**Environmental Assessment of Multiklient Invest
Newfoundland and Labrador Offshore Seismic Program,
2017–2026 Addendum**

**November 2017
Project No. FA0106-1**

This document is an Addendum to the Environmental Assessment (EA) of Multiklient Invest Newfoundland and Labrador Offshore Seismic Program, 2017–2026. It provides responses to the comments generated during review of the EA.

Figure 4.40 Location of Sensitive Areas that Overlap the MKI Study Area.

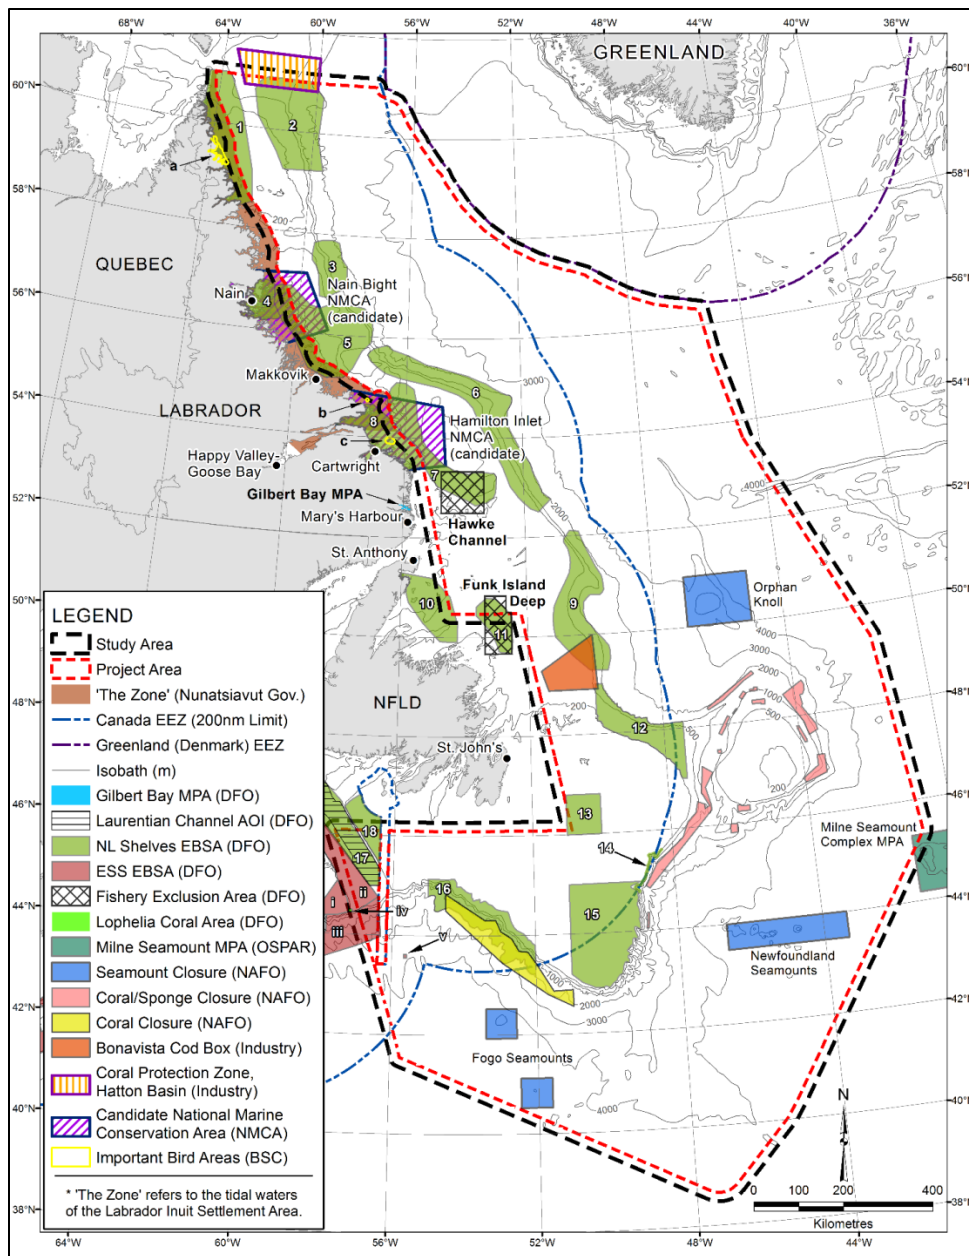
Section 4.7.1 Sensitive Areas within the Study Area, Figure 4.40, page 160 – this figure depicts the Bonavista Cod Box as a DFO area, it should be noted that is an area that fishers recognize as an important cod spawning area however it is currently not under any protective measures by DFO.

Response: Noted. Replace Figure 4.40 with the figure below (note that the PB-GB EBSAs are now included with the NL Shelves EBSAs in the figure below, reflecting the new information provided in the previous comment):
